Work Order ID 92856

Item Name: Crosstube Turning Detail

| DRAWING NO. D212-664-141 | TITLE XTUBE ASSY (205/212/412 HI FWD) | REV. D | DART AEROSPACE LTD ENGINEERING ORDER | | D.E.O. NO. D212-664-141-D-1 | SHEET NO. SHEET 1 OF 2 | SCALE NTS |

PURPOSE:
ADD AN INSPECTION WINDOW TO UNDERSIDE OF CROSSTUBE.

**D212-664-141/141B
ASSEMBLY DETAIL**

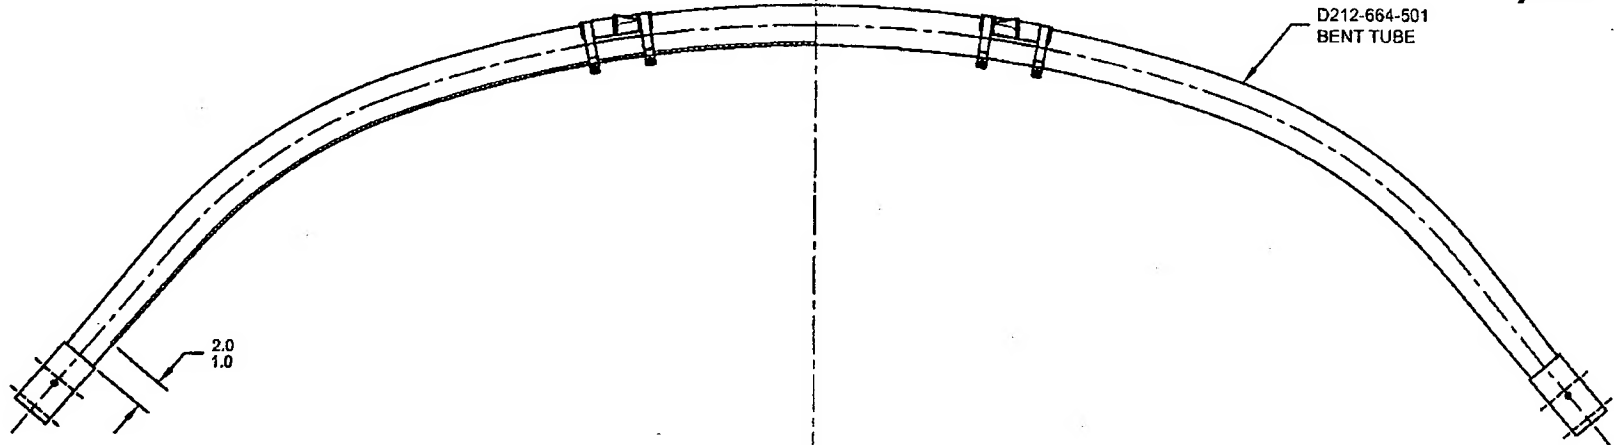
NOTES 2 OF SHEET 1 IS AMENDED AS FOLLOWS:

MASK AREA PRIOR TO PAINTING.
REMOVE MASKING AFTER PAINT
AND APPLY CLEAR COAT

- 2) FINISH: CHEMICAL CONVERSION COAT PER DART QSI 005 4.1
PRIME INSIDE AND OUTSIDE PER DART QSI 005 4.2
MASK UNDERSIDE OF CROSSTUBE AS SHOWN (HATCHED AREA) AND
PAINT OUTSIDE PER DART QSI 005 4.2
REMOVE MASKING AND APPLY CLEAR COAT
